HORSHAM DISTRICT COUNCIL CONSULTATION

REFERENCE:	DC/25/1312
RECOMMENDATION:	Advice / No Objection / Objection / More Information / Modification / Refusal
SUMMARY OF COMMENTS & RECOMMENDATION:	
<ul style="list-style-type: none">Clarification is required regarding the location and size of open space typologies.Further investigation required on the type of youth activity area to provide.Ensure that school land is not included within public open space quantities.

Open space typologies – quality, quantity, accessibility

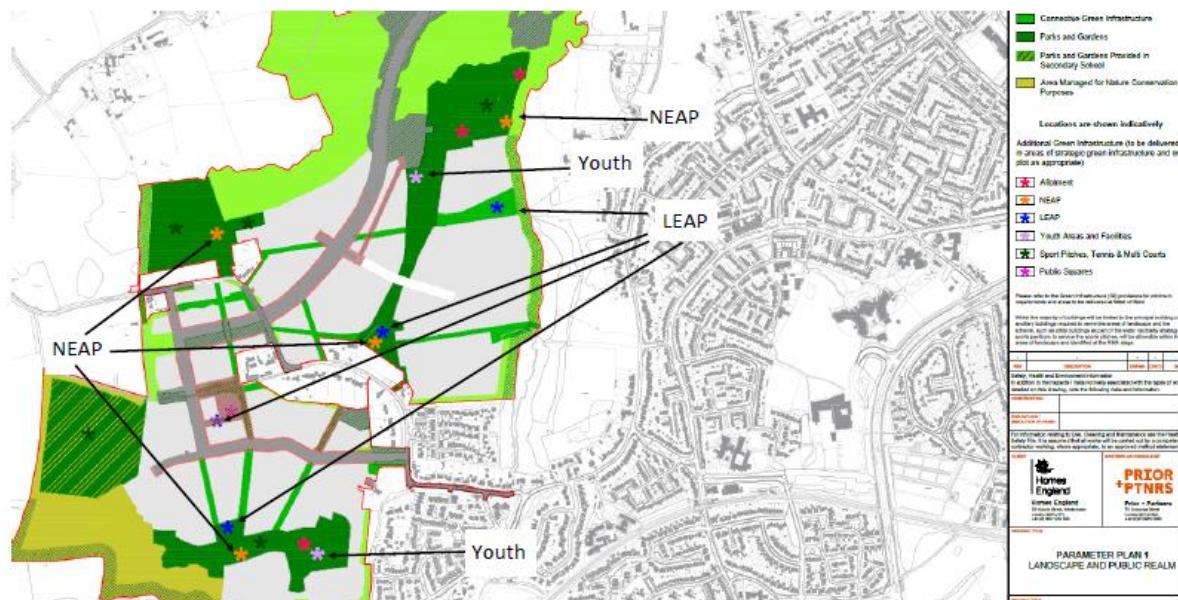
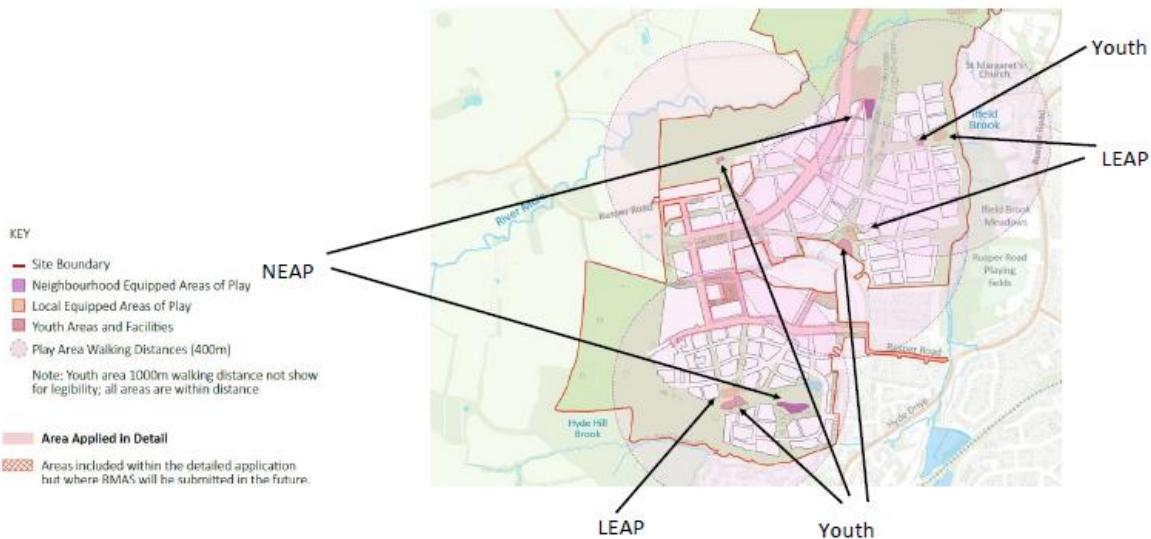
- 3) The Neighbourhood Park areas look very constrained in terms of size, considering proximity to attenuation basins and woodland. They appear to just be providing for sport and not integrated into a wider parkland setting. Further details on dimensions are needed in order to properly assess the suitability of the location. The proximity of attenuation basins next to pitches would require the provision of fencing to prevent the balls running into the basins. This would be an unfortunate detraction from the natural setting.

Please provide a scaled plan of neighbourhood parks showing the dimensions of pitches and the proximity of attenuation basins and woodland to the edge of the pitches.
